**Addendum No. 1**  
**CAMPELLO CAPACITY INCREASE – SPRING CREEK 6 BPS**  
PWP Bid No.: WA-2019-181  
TMWA Capital Project No.: 15-0056  
April 9, 2019

# CAMPELLO CAPACITY INCREASE - SPRING CREEK 6 BPS

**G000**  
SHEET 1 OF 17

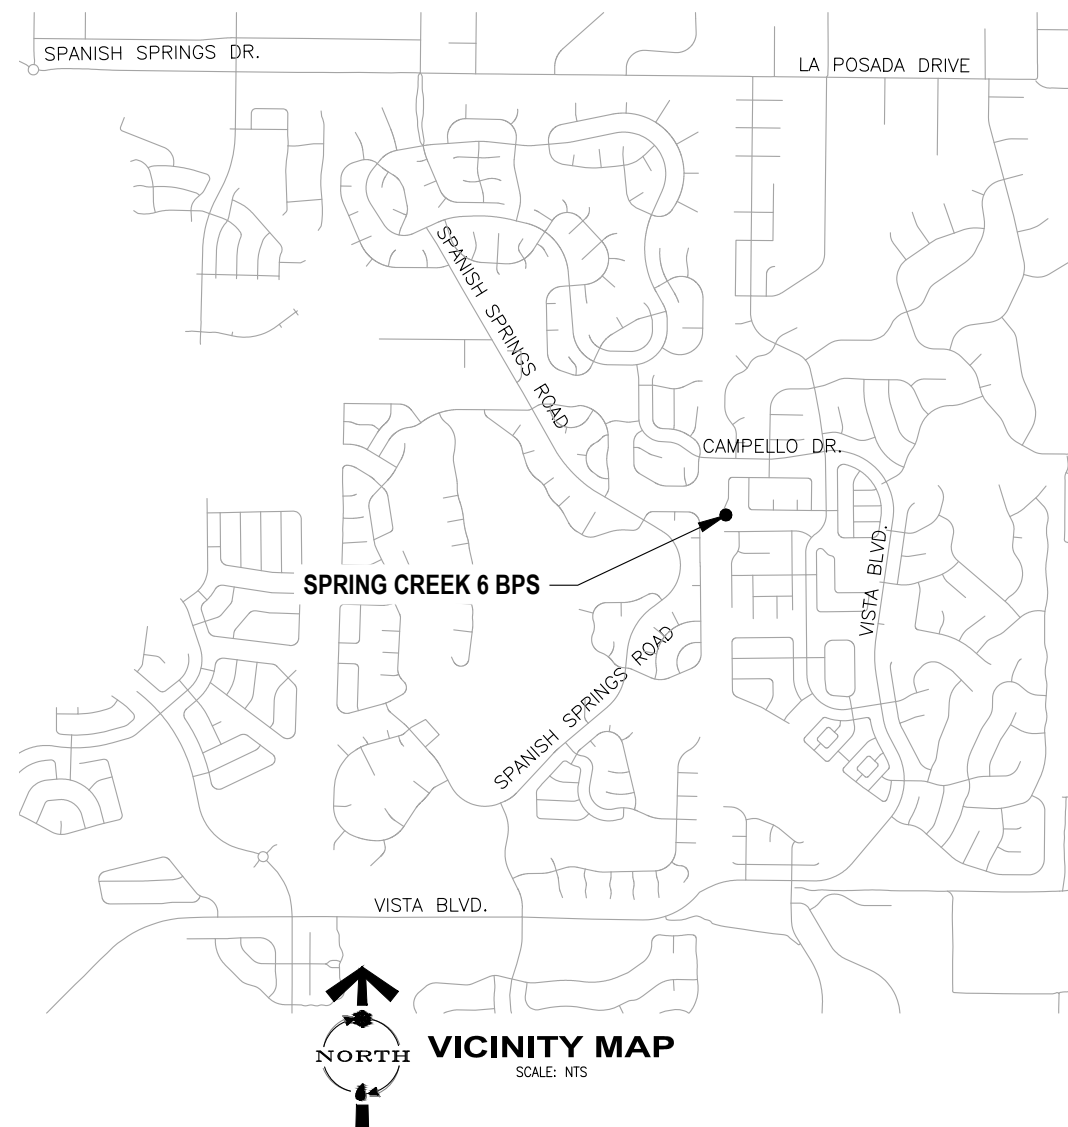
**Clarification Item No. 2:** The total sheet count in the bottom right corner of the Cover Sheet was incorrect. There is a total of 17 sheets as shown in the sheet index.

CHLORINE INJECTION ASSEMBLY

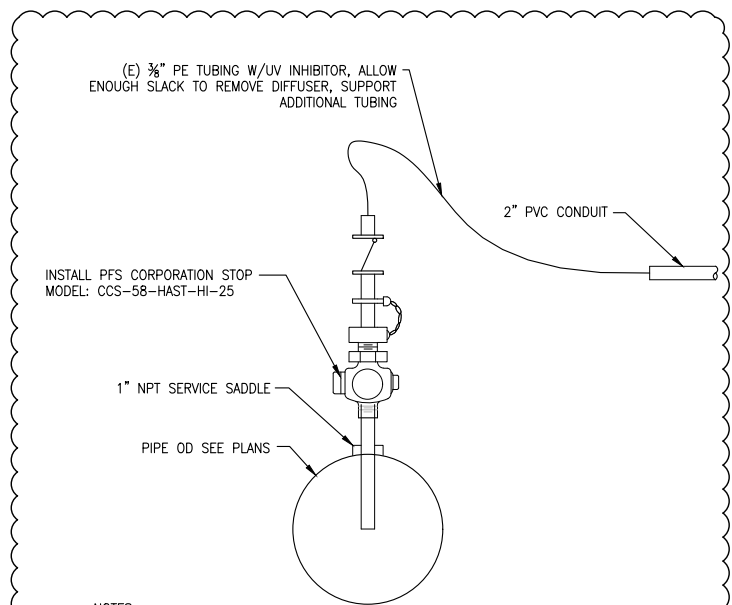
**Clarification Item No. 1:** Project plans and specifications originally call out to remove and re-install the existing chlorine injection assembly. The plan will now remove and discard existing chlorine injector and install new injector per detail M112/TYP on sheet M001. Notes have been changed on sheets on M100 and M101.
